THE HIGHWAY TRAFFIC ACT (C.C.S.M. c. H60)

Traffic Control Devices Order, amendment

Regulation 34/2006 Registered February 22, 2006

Manitoba Regulation 264/88 amended

Maximum 40 When Meeting Traffic sign (MR-136 and MR-136F)

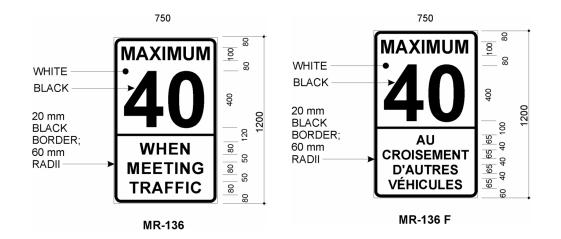
2 The following is added after section 65.17 of the Schedule:

65.18(1) A "Maximum 40 When Meeting Traffic" sign may be used to indicate to drivers to reduce their speed when meeting oncoming vehicles within the project limits of seal coat application projects.

65.18(2) A "Maximum 40 When Meeting Traffic" sign shall

- (a) be rectangular in shape and erected so that the long dimension is vertical;
- (b) be not less than 750 mm in width and 1200 mm in height;
- (c) be white in colour and display the word "Maximum" in black upper case letters not less than 100 mm in height, the figure "40" in black figures not less than 400 mm in height and the words "When Meeting Traffic" in black upper case letters not less than 80 mm in height;
- (d) be available in a bilingual format as shown in the illustration;
- (e) be reflectorized to show the same colour and shape by night as by day; and
- (f) bear the markings and have the dimensions illustrated in the following figure:
